Submission: Review of Power System Data Communication Standard Issues Paper

CS Energy welcomes the opportunity to provide a submission to the Australian Energy Market Operator's (AEMO's) *Review of Power System Data Communication Standard Issues Paper (Issues paper)*.

Figure 2 PFR influence on AEMO 5 Minute Dispatch MW Error.

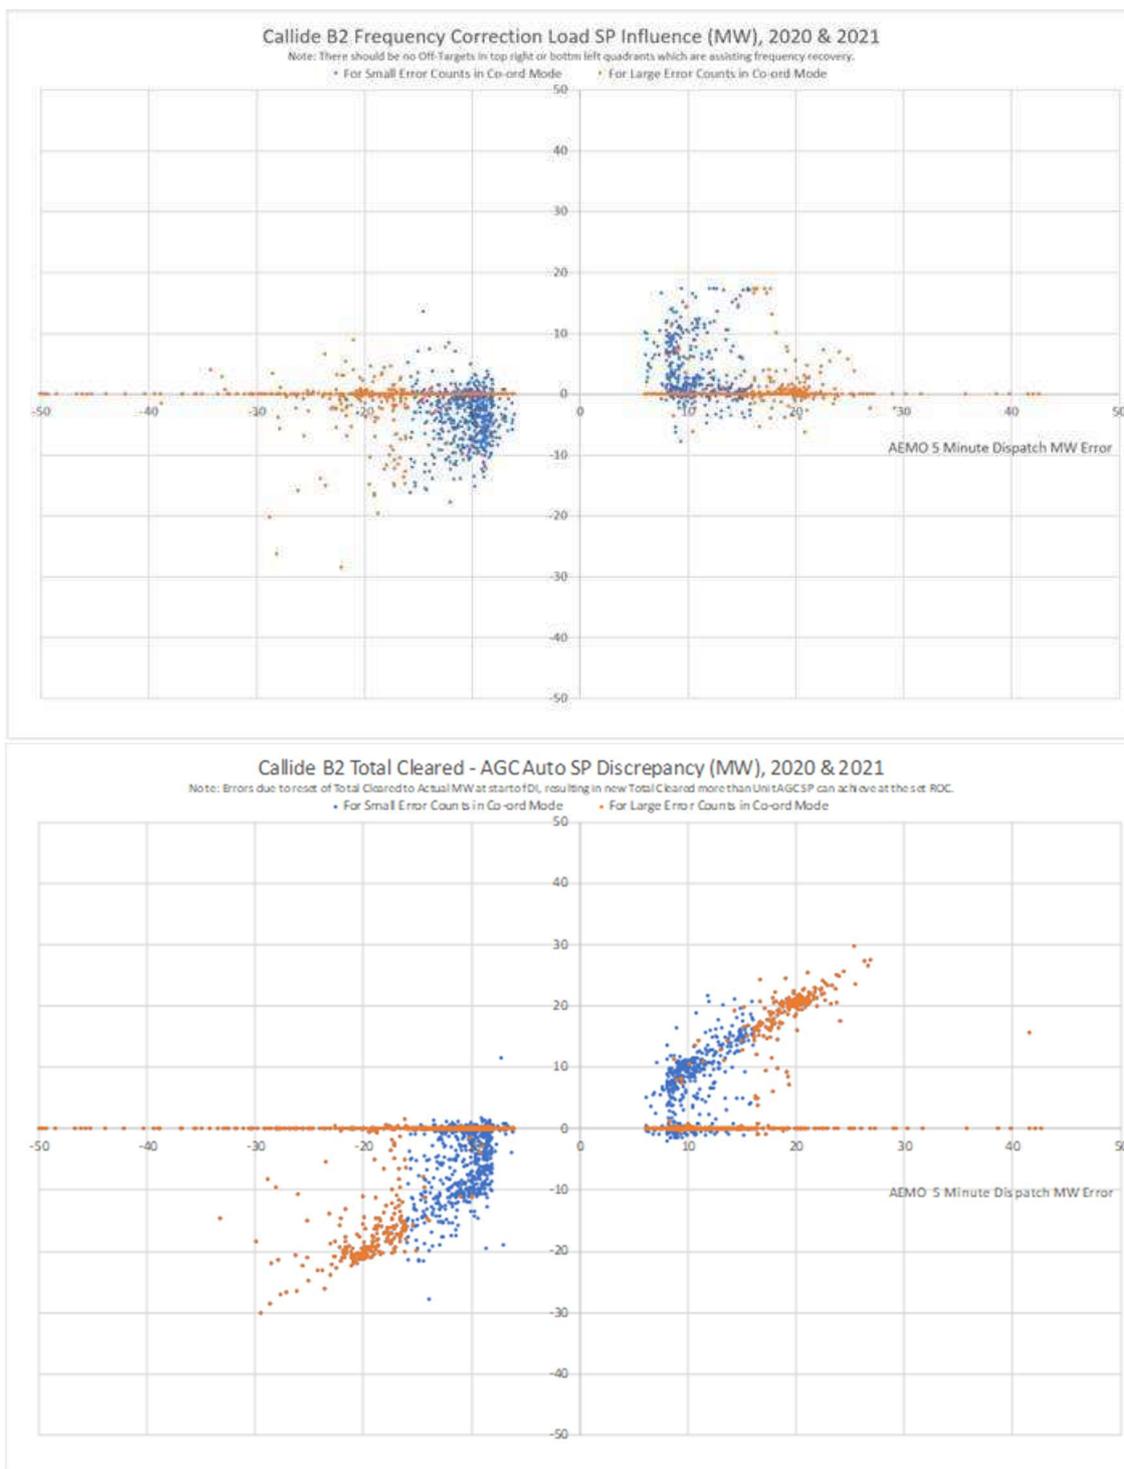
- AEMO's dispatch conformance alert system is yet to align with the Primary Frequency Response (**PFR**) rule changes made under the 'Removing disincentives to providing PFR' rule change process that are intended to clearly legitimise being off target to help correct frequency. Traders continue to receive "Off Target" alerts despite PFR contributing to a significant portion of the "MW Error" in AEMO's dispatch compliance system due to (a) the discrepancy between the "Total Cleared" in AEMO's Automatic Generation Control (**AGC**) system and the actual AGC setpoints seen by generators when PFR provides a head start to load ramping, and (b) PFR itself still being included in the "MW Error", which is simply "Total Cleared" minus "Actual MW". (see Figure 2). This then potentially impacts subsequent decisions.

- Participants do not receive a linear AGC setpoint ramp. This appears to be principally due to resetting the "Total Cleared MW" to "Actual MW" at the start of each Dispatch Interval (**DI**). The resultant flat spots in AGC ramps at DI boundaries if "Actual MW" is lagging an AGC setpoint ramp before the start of the DI, and the inconsistent ramp rate between DIs is directly responsible for degrading the ramping response of generators.

- The AGC setpoint ramping should not be reset to Actual MW every DI, rather it should just continue from the AGC setpoint at the end of the previous DI with no pause. In this way, it would be decoupled from any PFR influence. Unlike AGC setpoint changes, PFR is not rate limited and should not be allowed to alter the base AGC setpoint ramping. If the reason for resetting "Total Cleared MW" to "Actual MW" at the start of each DI is because the energy market dispatch engine does not account for the influence of frequency deviations on system load, then AEMO needs to model the frequency influence on load and generation and factor into the dispatch an estimate of the change in generation needed to correct frequency.

- The non-linearities in AEMO's AGC setpoint ramping distort the legitimacy of any causer-pays framework. Causer pays performance factors are judged by comparing actual MWs against a linear trajectory between dispatch targets, whereas they should be judged against the AGC set points as received by the generator and that are sent back to AEMO with the actual MWs.

There is strong case to push strongly for the DSCP response to be measured against each unit’s rate limited AGC target, which is send back to AEMO together with the actual load. This would also avoid timing discrepancies between the two principal values being compared, which could otherwise be another significant source of error. Why assume a linear trajectory when the trajectory is precisely known at the same time as each load measurement? Using the unit’s AGC setpoint may incentivise AEMO to update its AGC system to include a linear ramp as the non-linear AGC setpoint ramping causes sub-optimal unit control by pushing rate of change feed-forward influences in and out.
